ADDENDUM #2

Reference: Monument Valley Vendor Village
Utah Navajo Trust Fund
DFCM Project 03272300

Subject: **Addendum No. 2**

ADDENDUM NUMBER TWO

1 COILING DOOR HEAD DETAIL
 SD-02b SCALE: 3" = 1'-0"

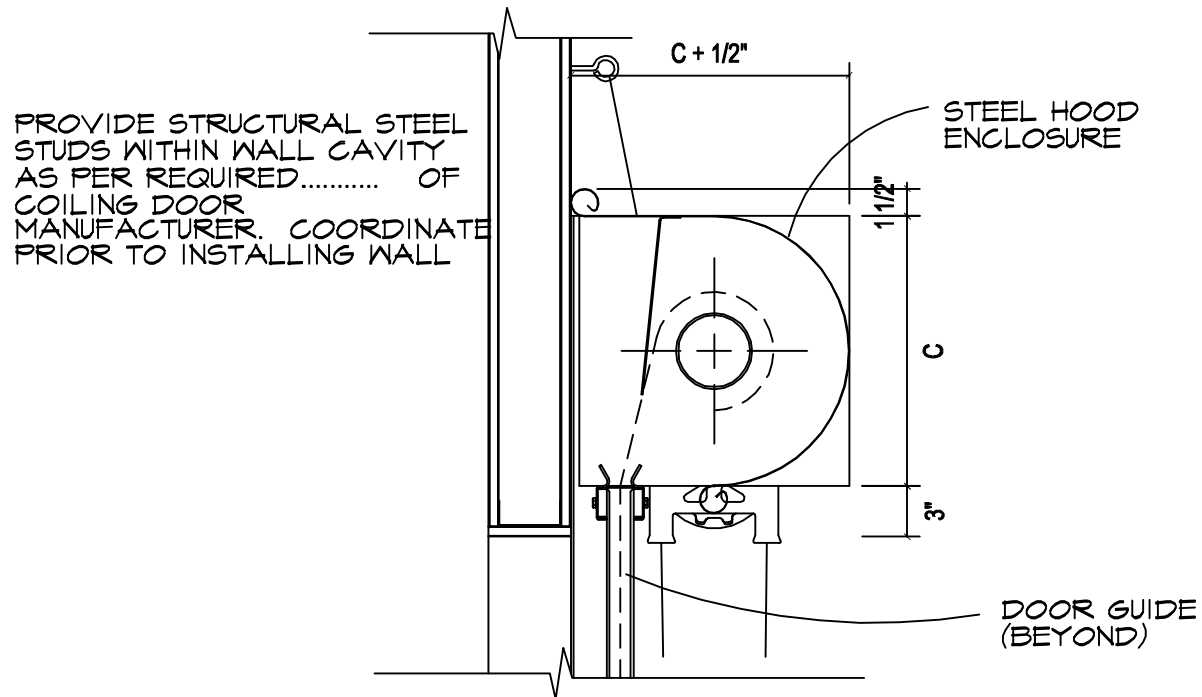
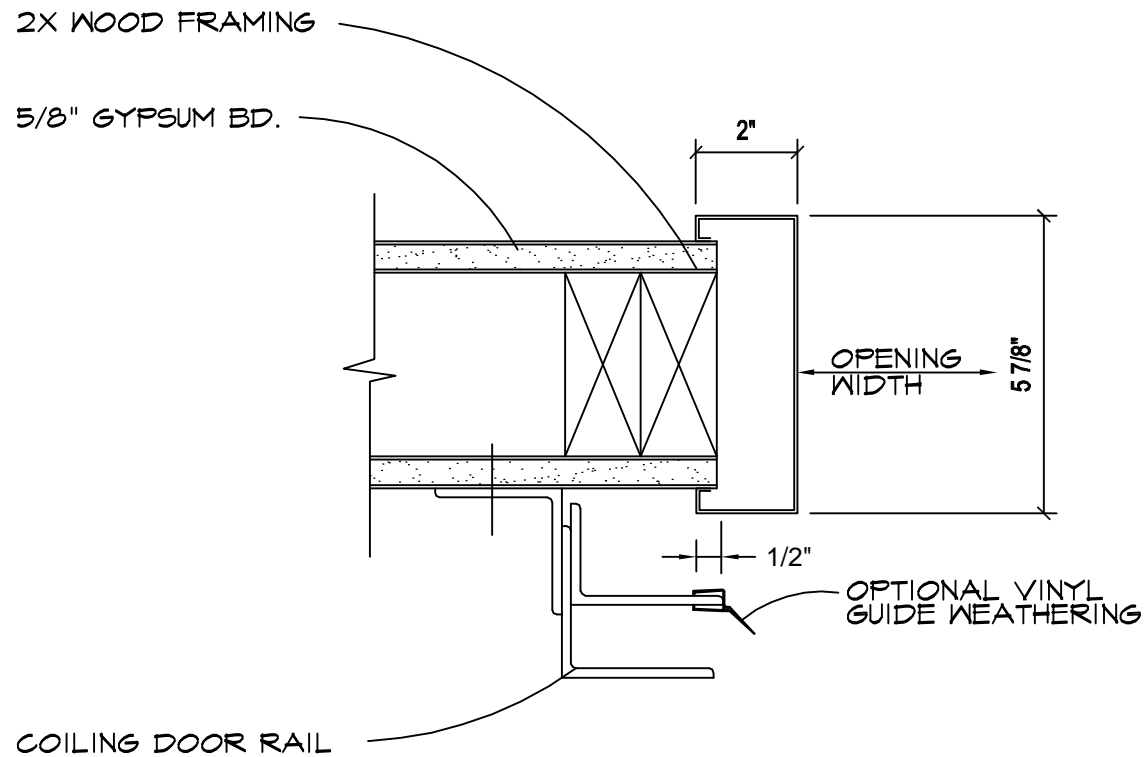
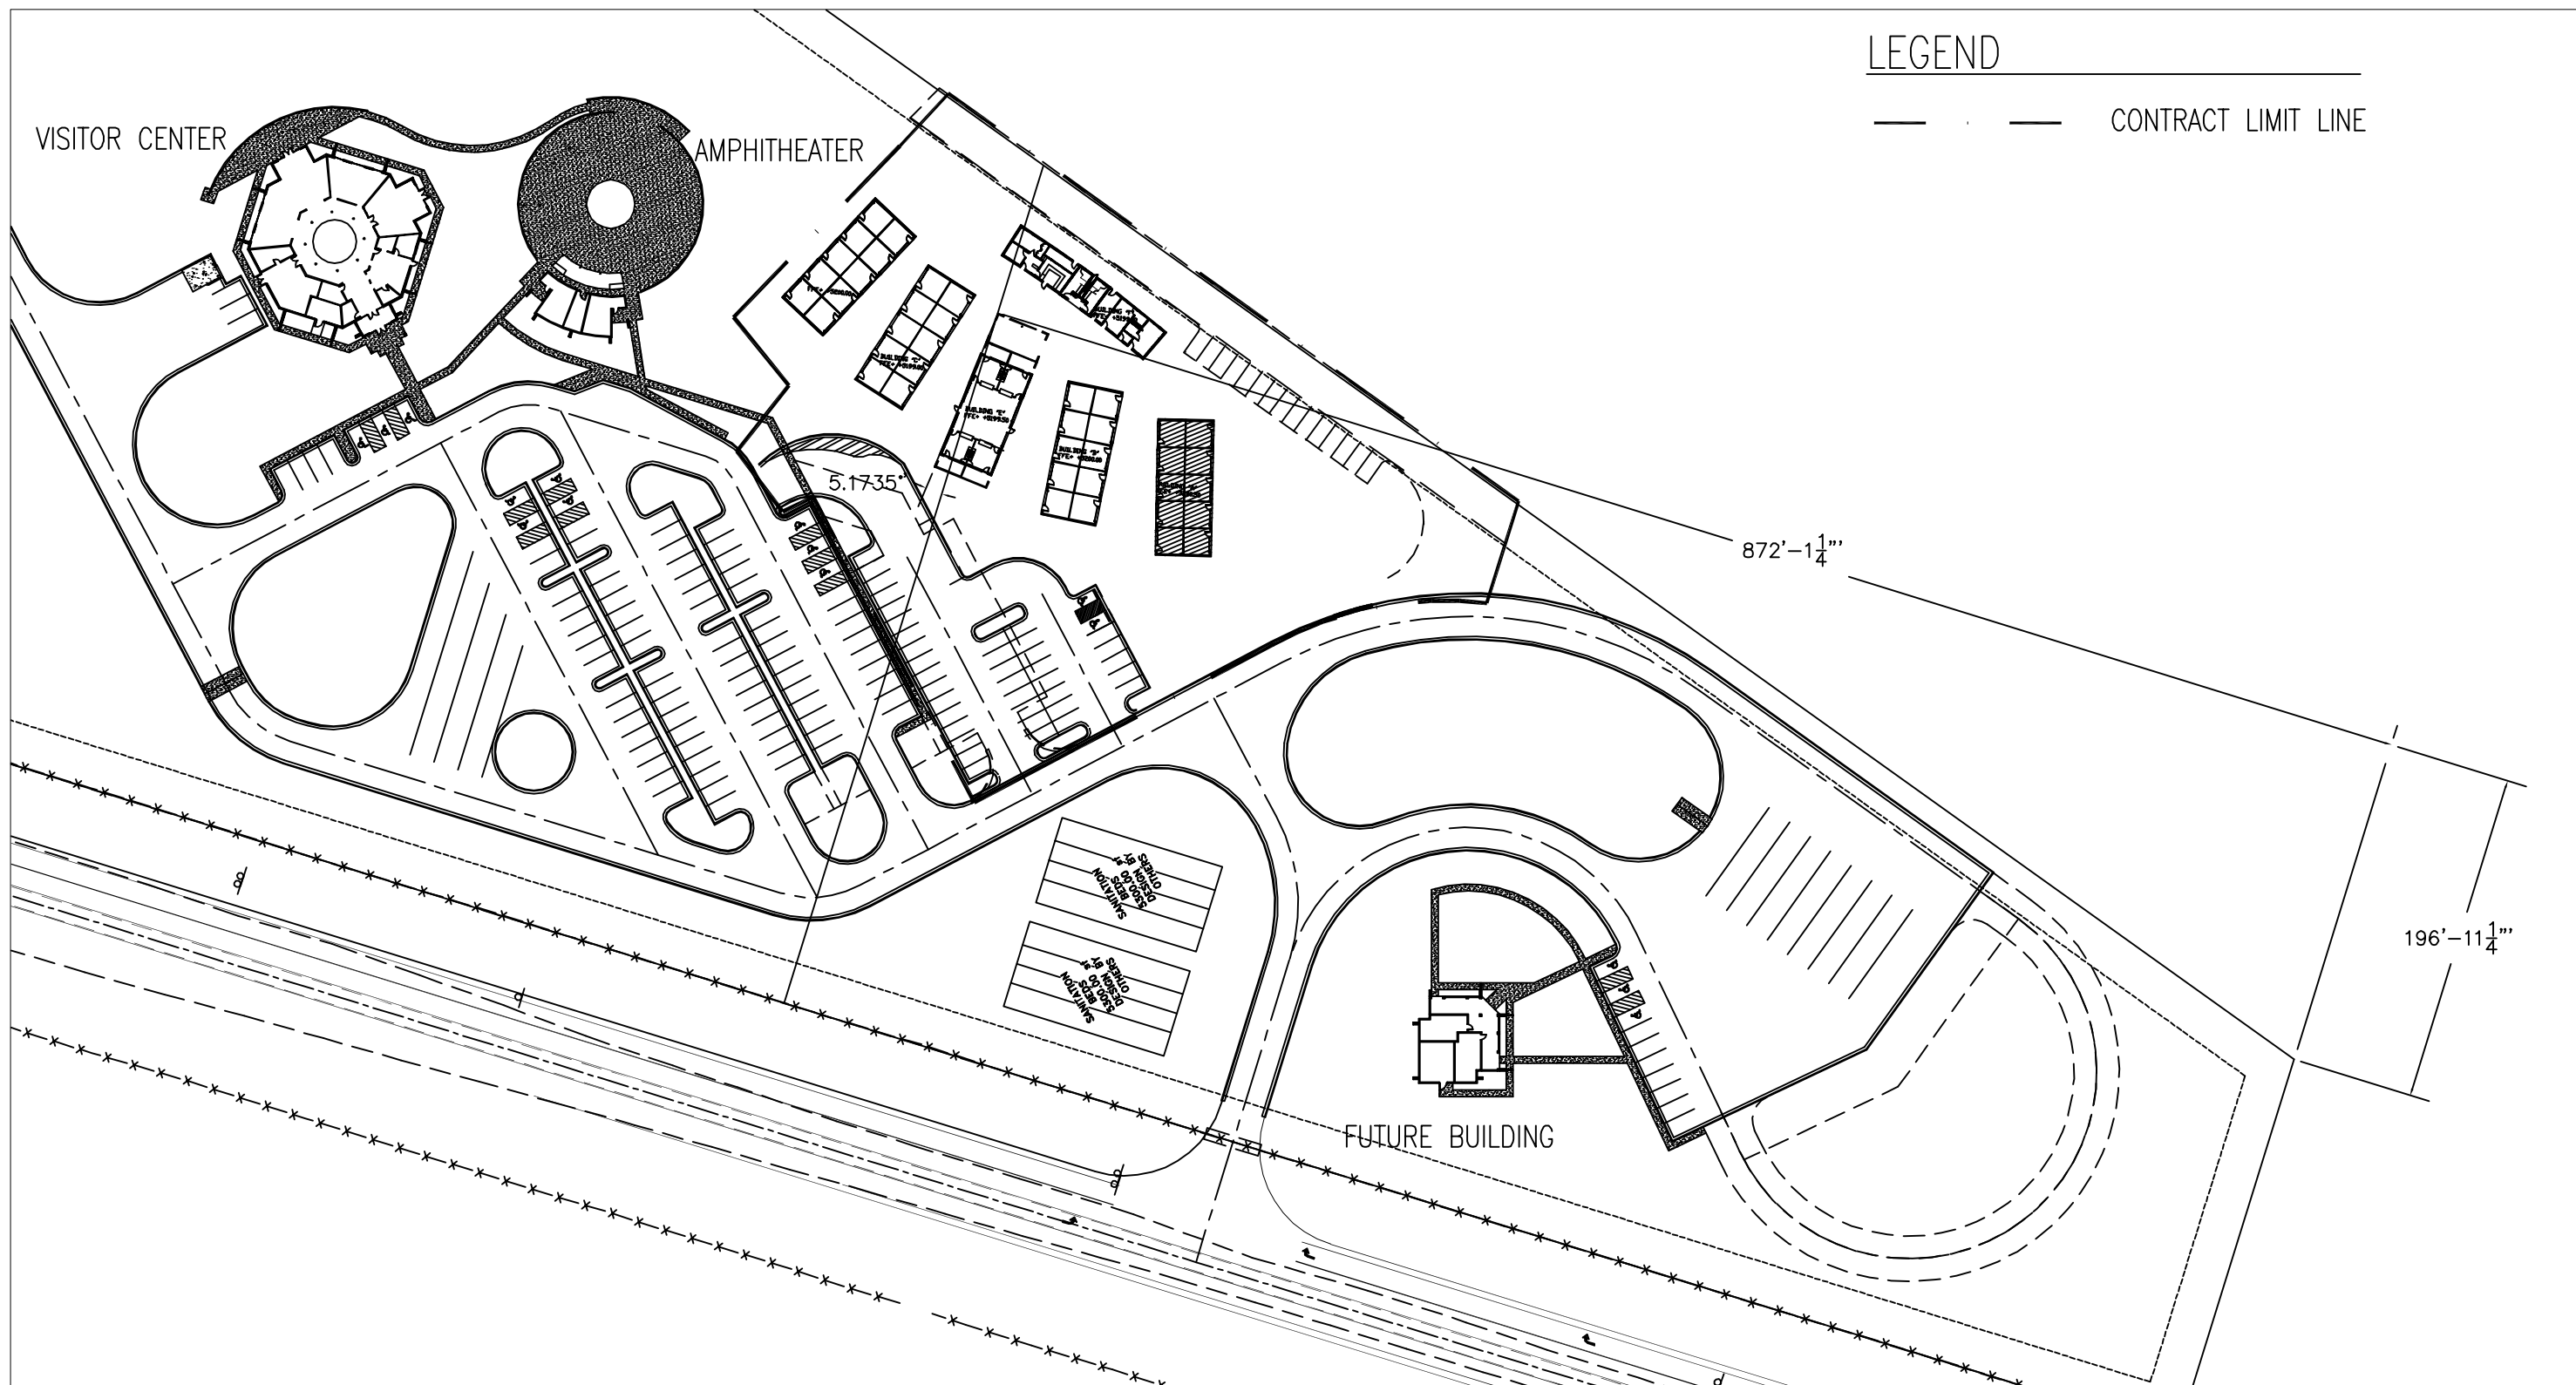
- c. Change Grid designations on this sheet to contain "E" instead of "B" designations as currently shown.
- d. Change designation of (4) coiling doors from Door – 2G to new door 2E. Refer to supplemental drawings provided within this addendum for added information – SD-02, sheets a, b & c. See specification section 08331 provided as part of this specification for three coiling doors.

MASTER PLAN
SCALE: N.T.S.

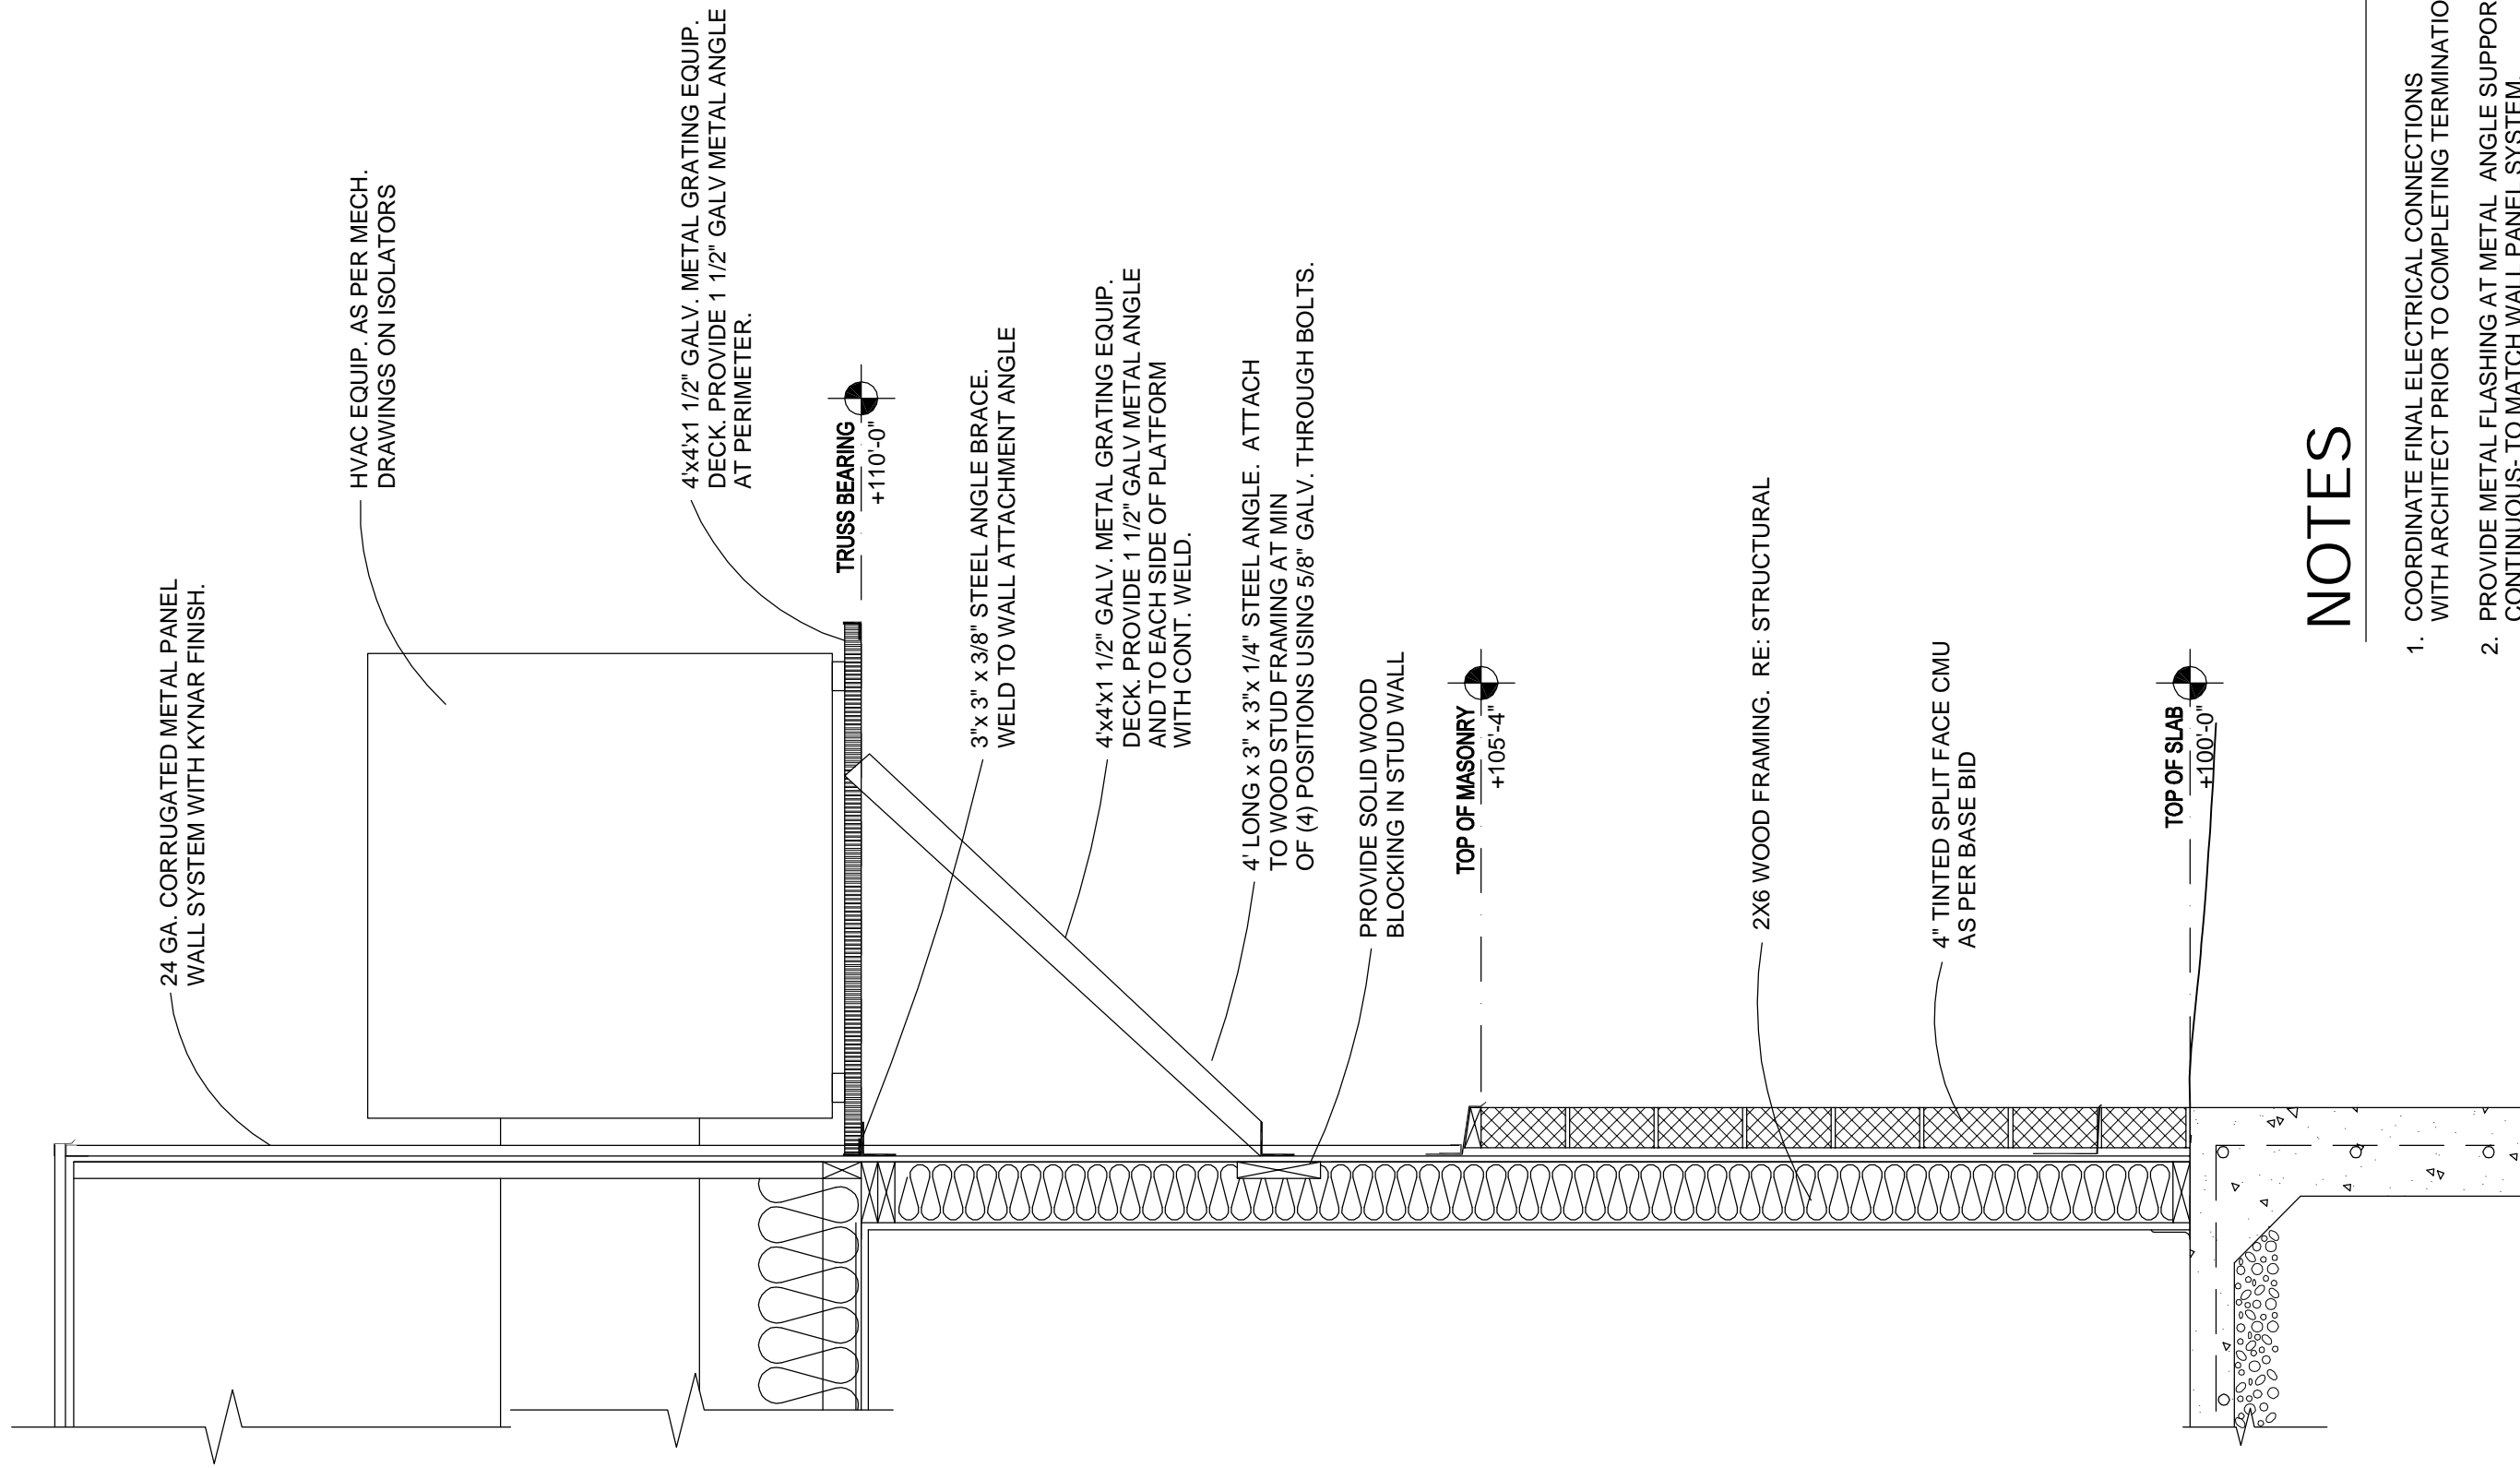
2. Regarding Sheet C102
 - a. Regarding Reference Note No. 1 – “Site Masterplan” is included as part of this addendum (SD-3a & b). Plan provided is to be used for general location of items not included as part of this contract and to provide specific direction on the location of Building “E” included as part of this base bid. All final locations shall be verified with adjacent contractor as required.
